Access Compliance Report

Public Rights-of-Way

Intersection ID: 27177	Main Street: PROVIDENCE_RD	Cross Street: MCKEE_RD	Location: SE
ADA ID: 02E78CBB474F	Ramp Type: Perp	Initial Pass/Fail: Pass	Overall Compliance: No
		Severity Score: 10

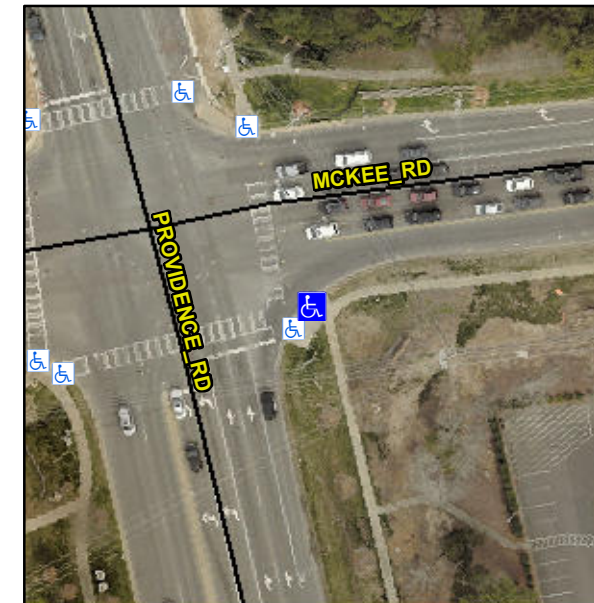
Not Found, R304.2.2-Perp, R304.3.2-Para, R305

Remove & Replace Entire Ramp.
